# AXC F 2152 – CHANGE NOTES

## Change notes for the AXC F 2152 controller

108427\_en\_24

This document contains all changes made between firmware version 1.0.0 and the current firmware version of the AXC F 2152 controller (Order No. 2404267).

#### Left-alignable INTERBUS master

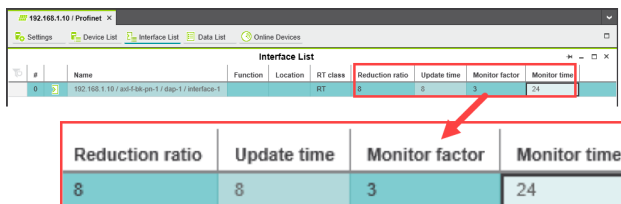
The controller now supports left-alignment of the INTERBUS AXC F XT IB master (Order No. 2403018).

Figure 2 Select Trigger task

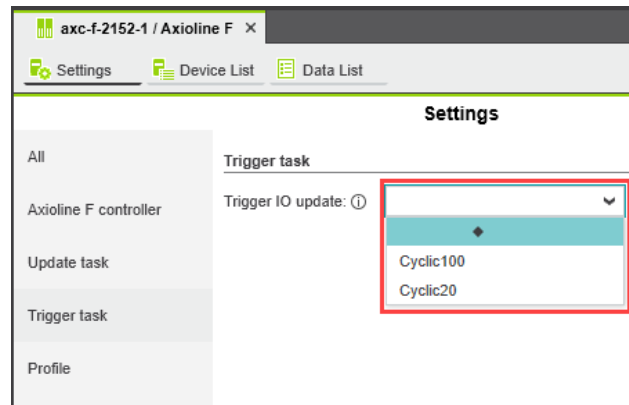
- Select the “Trigger task” view in the “Settings” editor.
- In the drop-down list, select the task that is to trigger the Axioline F I/O data update.

If you do not select a task, the update will occur by default every 50 ms.
